REVISED RESPONSE TO REQUEST FOR ADDITIONAL INFORMATION**APR1400 Design Certification****Korea Electric Power Corporation / Korea Hydro & Nuclear Power Co., LTD****Docket No. 52-046**

RAI No.: 179-8190

SRP Section: 09.01.01 - Criticality Safety of Fresh and Spent Fuel Storage and Handling

Question No. 09.01.01-15RAI 9.1.1-9: Deformation of neutron absorber material**REQUIREMENTS AND GUIDANCE**

Figure 3.7.16-1 (page 1 of 1)
Discharge Burnup vs. Initial Enrichment for Region II Racks

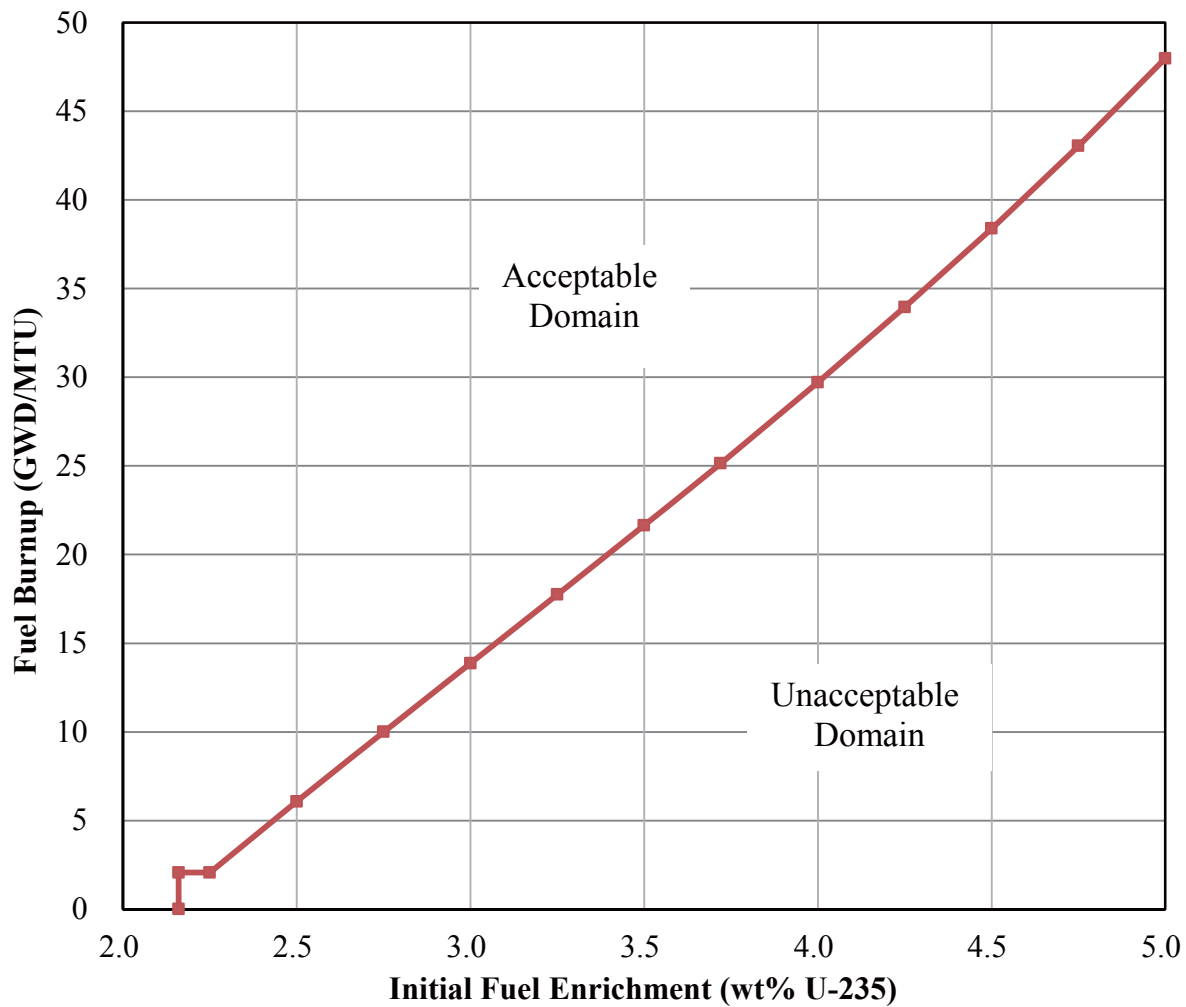
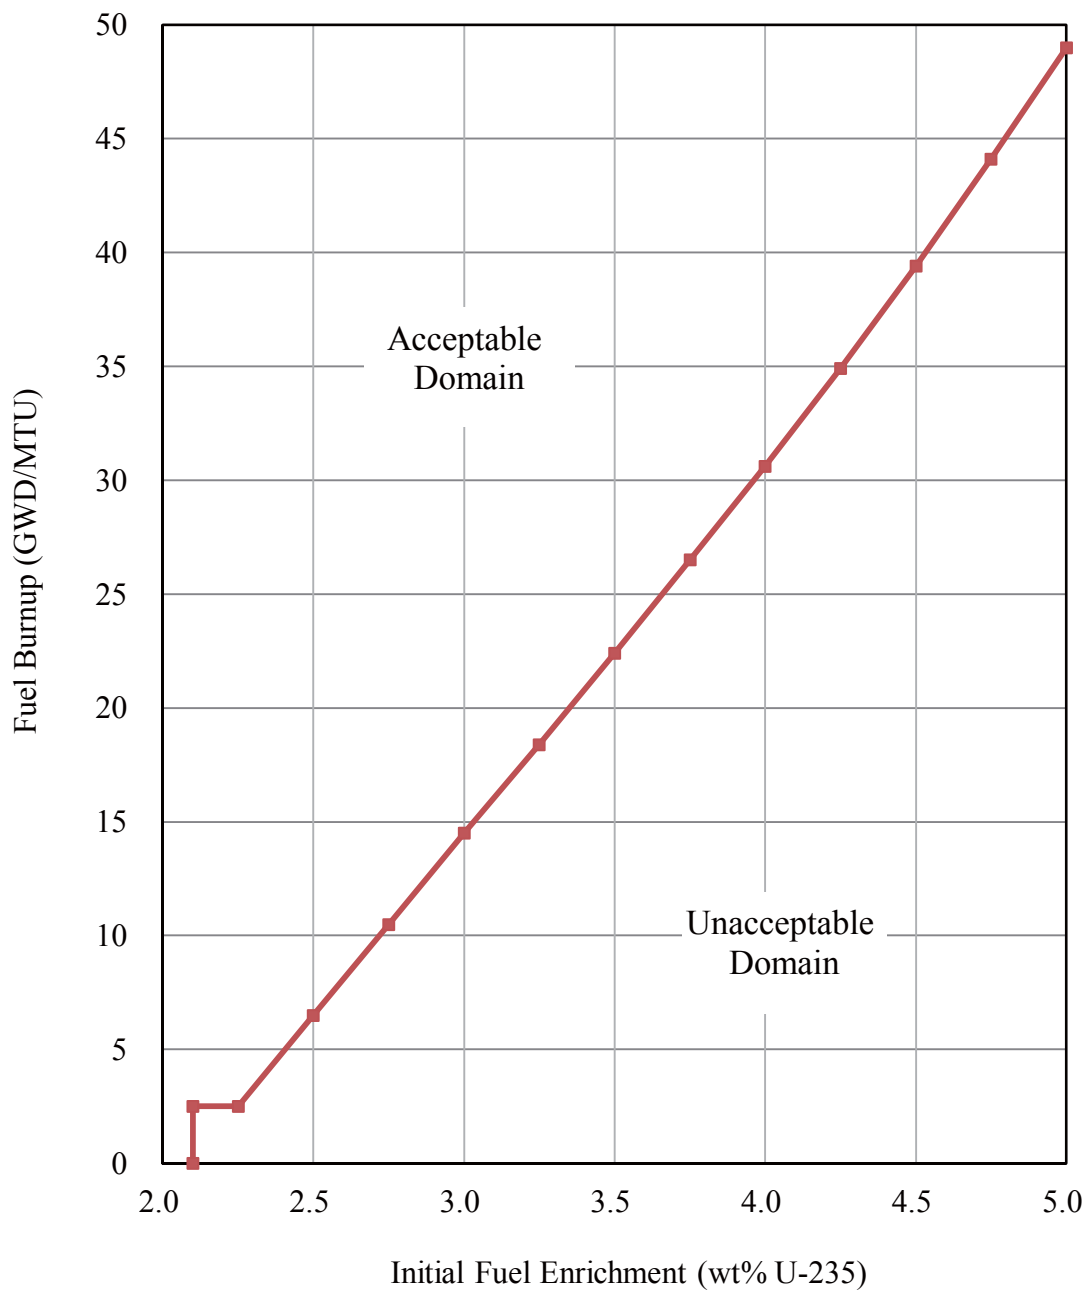
The criticality analysis report does not clearly present the analysis results that show compliance with the regulatory requirement to demonstrate that the neutron multiplication factor k_{eff} without soluble boron remains below 1.0 at a 95 percent probability, 95 percent confidence level. The report's Table 3.5-24 lists ranges of k_{eff} values that support development of the burnup credit loading curve but these include values above 1.0.

The applicant should provide in its response and in the DCD or its incorporated references the final analysis results that clearly show compliance without soluble boron. In particular, the analysis results should indicate the compliance margin by presenting a calculated maximum k_{eff} value that is a finite amount less than 1.0 at a 95 percent probability, 95 percent confidence level.

The loading curve provided in Figure 3.5-7 of the critical analysis technical report (TeR) was generated based on target k_{eff} of 1.0 with additional margin. However, it was found that k_{eff} of a fuel assembly with an initial enrichment of 4.5 wt% and burnup of 38.5 GWd/MTU slightly exceeds the regulatory limit ($k_{\text{eff}} < 1.0$). To correct this error, the loading curve was regenerated based on target k_{eff} of 0.998 with additional margin.

The regenerated loading curve is provided in Figure 1. The summary of the loading conditions (initial enrichment and minimum burnup) is provided in Table 1, and it is shown that final k_{eff} values are a finite amount less than 1.0 at a 95 percent probability, 95 percent confidence level.

The criticality analysis TeR and Figure 3.7.16-1 of technical specifications will be revised to incorporate the regenerated loading curve.

Figure 3.7.16-1 of technical specifications will be revised as indicated in Attachment 2.

Figure 2.4-2 Criticality Calculation Model for a Dropped Fuel Assembly Accident (Contact)

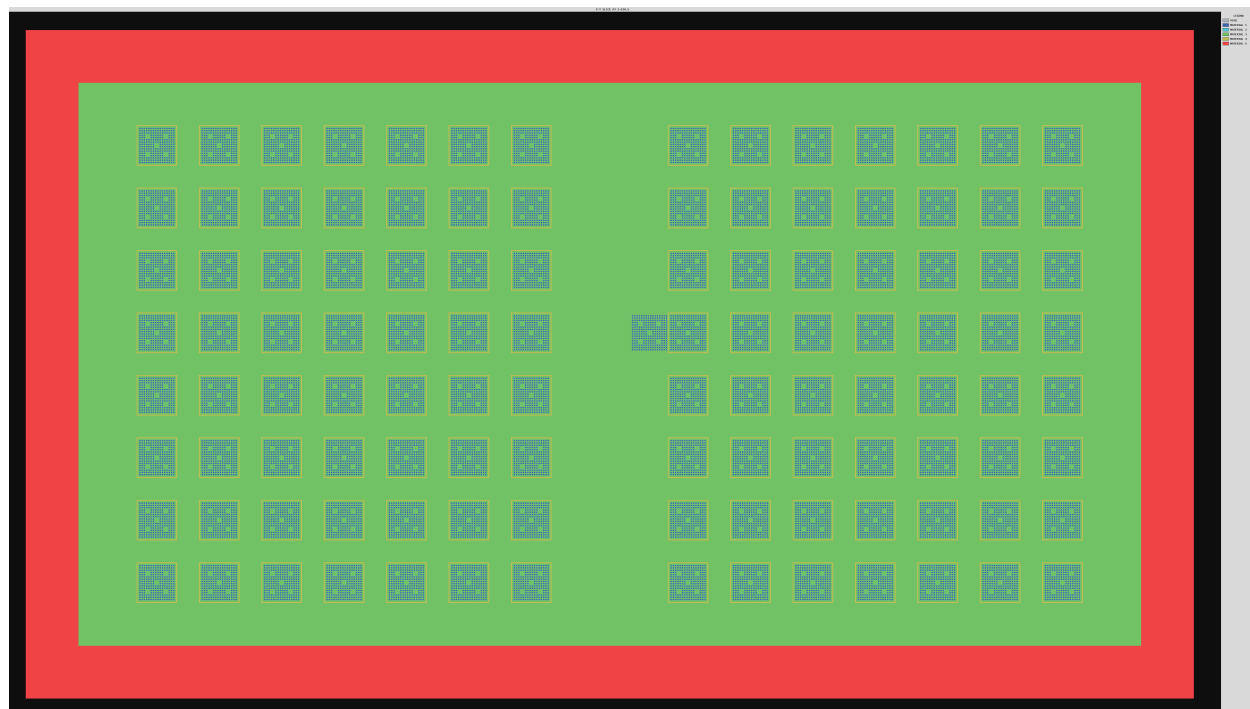
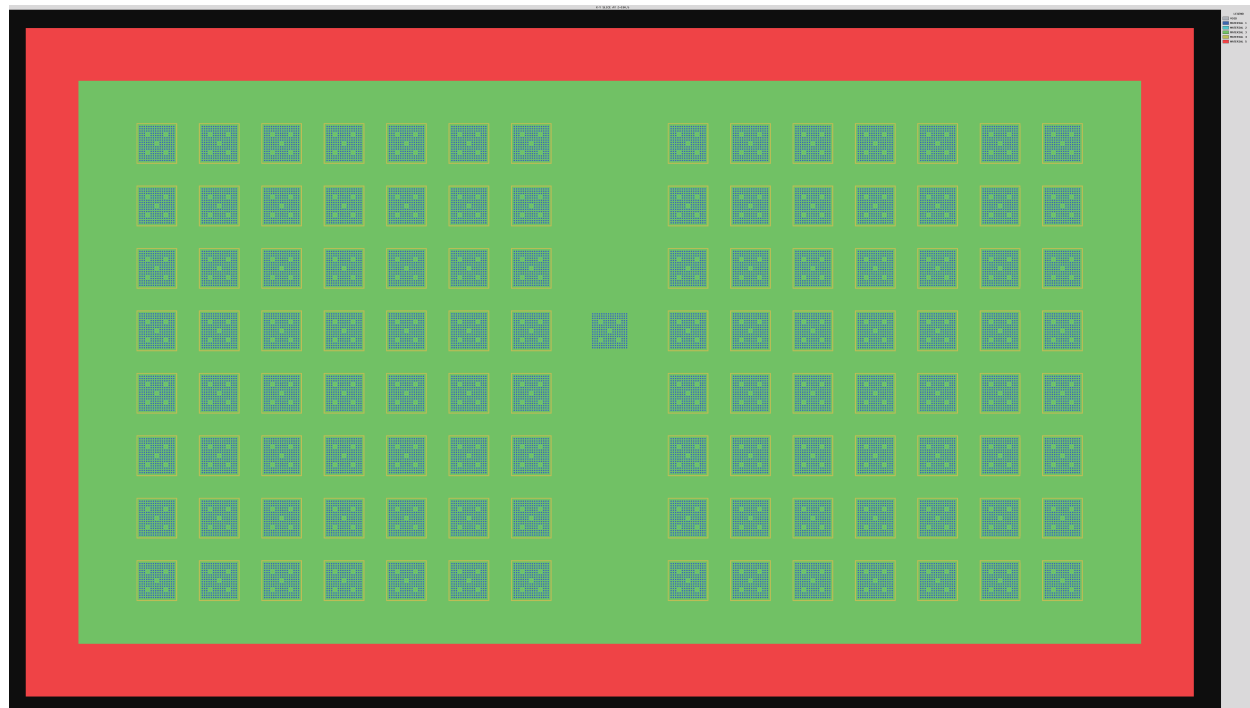
The applicant should describe in its response and in the DCD or its incorporated references additional sensitivity calculations on an analysis model that addresses the neutronic effects of storage pit concrete as well as the respective conditions of optimum moderation by low-density water and moderation by full-density water. The results of the supplemental

Sensitivity calculations on a finite array model describing the new fuel racks with storage pit concrete in optimum moderation and full-density water conditions have been performed to obtain uncertainties due to design tolerances. The criticality analysis TeR will be revised to include the sensitivity calculation results.

Sections 2.4.2 and 2.5, Tables 2.4-3, 2.4-4, and 2.5-1, Figures 2.4-2, 2.4-3, and 2.5-1 in the criticality analysis TeR will be revised as indicated in the attachment.

Figure 2.4-2 Unit Cell Model for Uncertainty Analysis

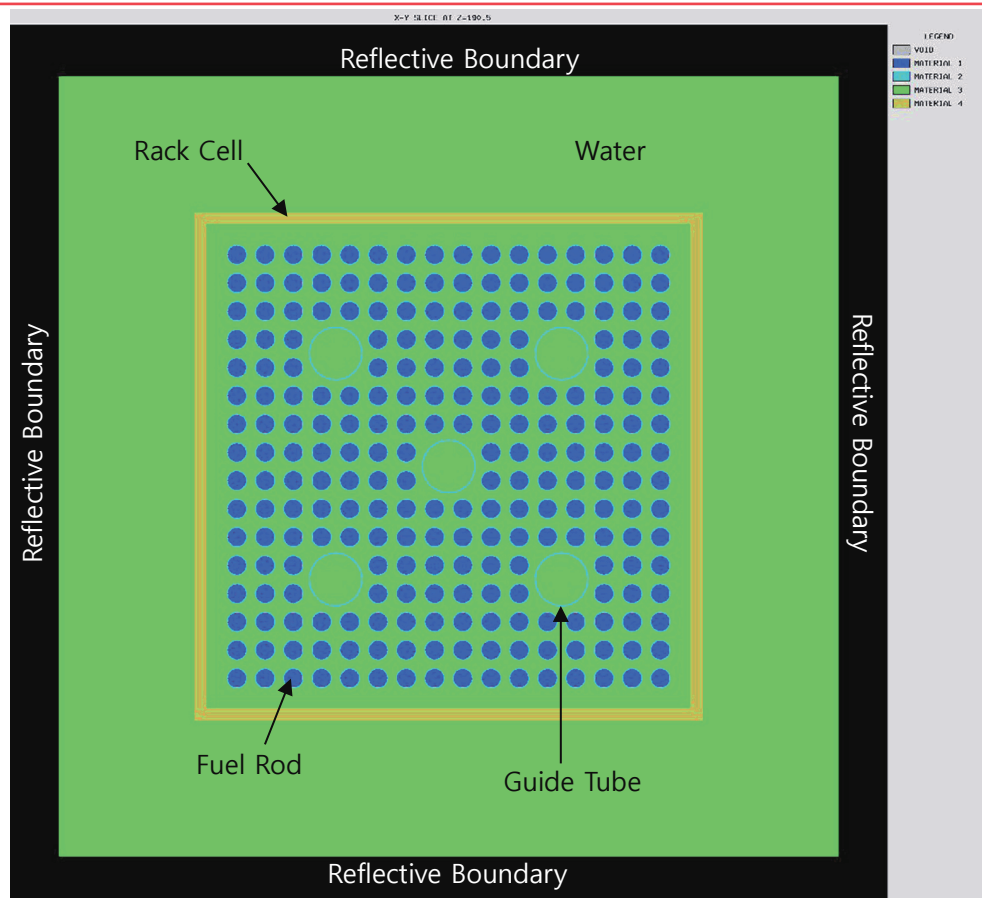
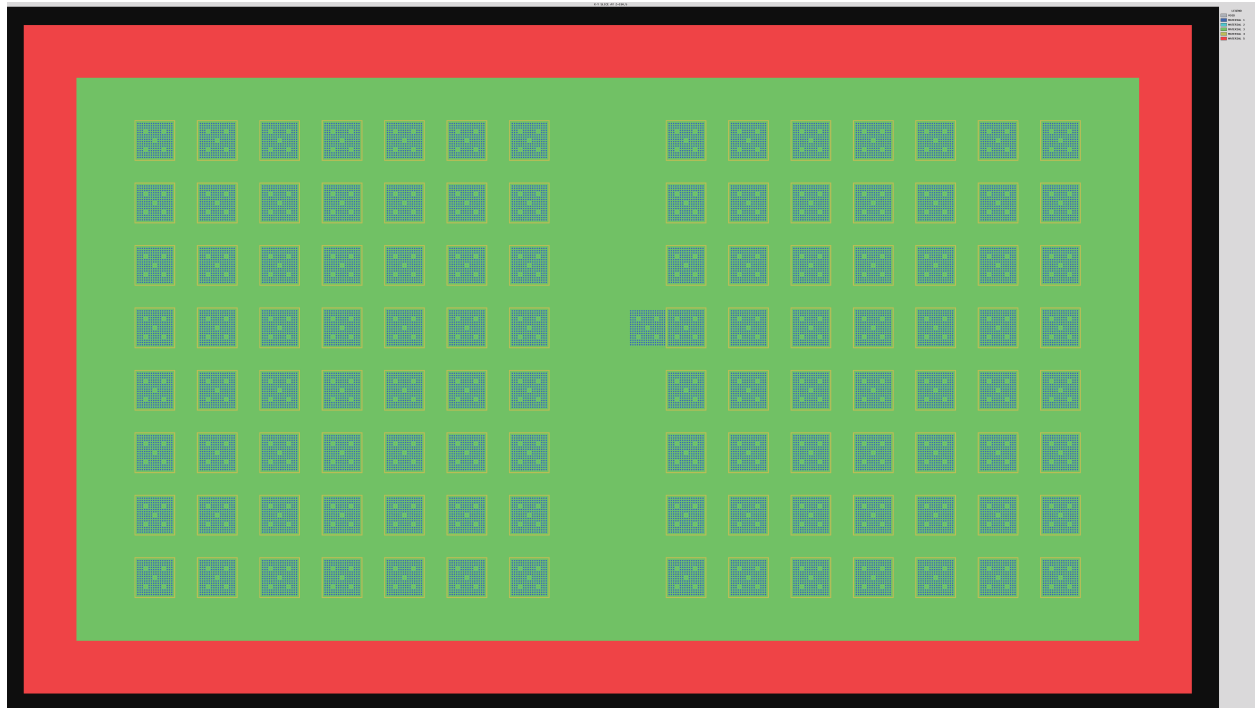
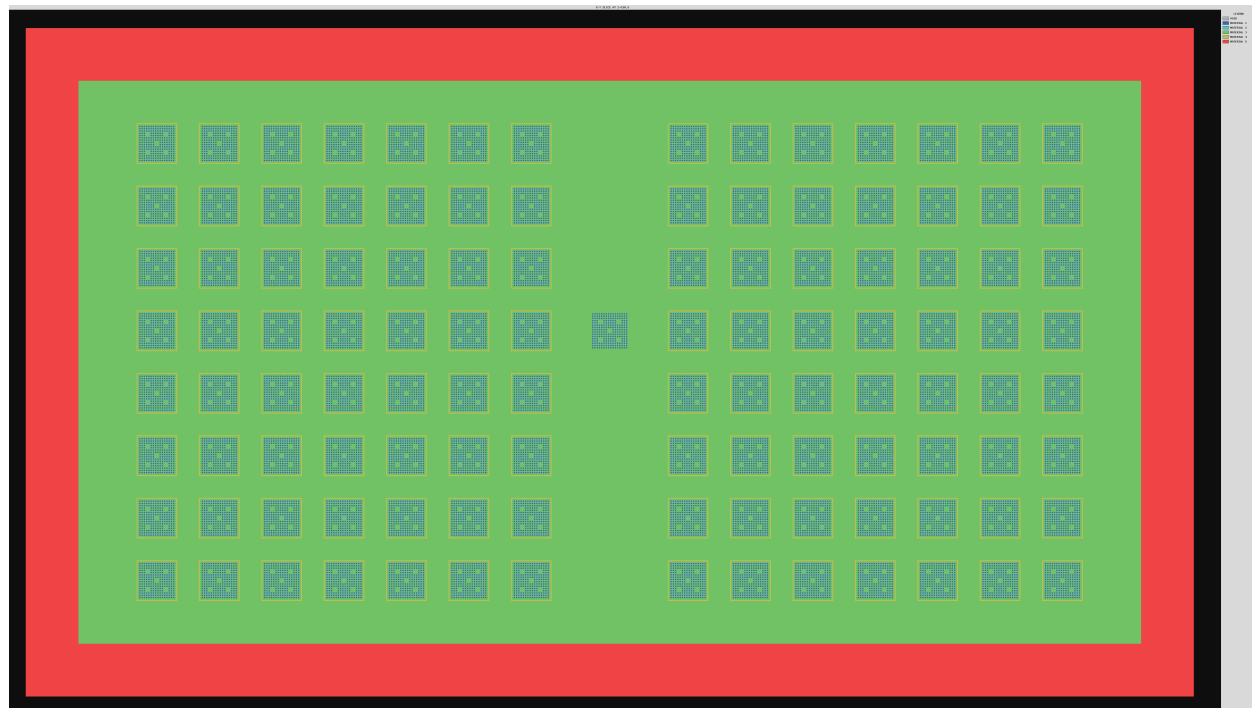
In its response and in the DCD or its incorporated reference, the applicant should either (1) provide justification for not including the uncertainty in uranium enrichment and both positive and negative dimensional variations or (2) update the sensitivity analysis for the new fuel storage racks to include these tolerances and apply the revised results to the new fuel storage rack criticality analysis accordingly.

Sensitivity analysis for the new fuel storage rack criticality uncertainty evaluation has been performed to include additional items such as uranium enrichment and both positive and negative tolerances in dimensions, such as fuel rod pitch, fuel clad diameter, and rack cell thickness. Criticality analysis TeR will be revised to include the additional sensitivity calculation results.

Sections 2.4.2 and 2.5, Tables 2.4-3, 2.4-4, and 2.5-1, Figures 2.4-2, 2.4-3, and 2.5-1 in the criticality TeR will be revised as indicated in the attachment.
